2 Type of change

- Change of location of final assembly of various PEM
- Change of country of origin of various PEM

Product Change Notification					PCN KEA		
owner	creation date	release date	released by	change order no	rev	page	D10-011-720
hotzar	2016-12-19	2016-12-19	hotzar	2011741	A	1 of 2

3 Detailed description of change

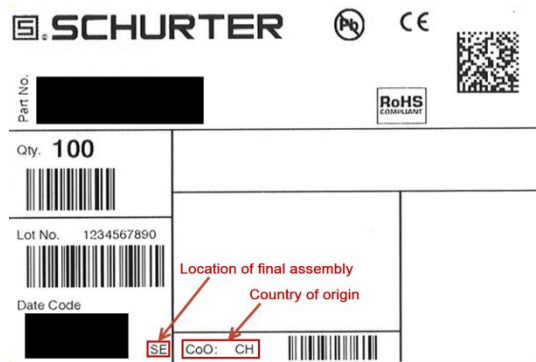
The location of final assembly and the country of origin of various fuse holders has changed from Switzerland to Czech Republic.
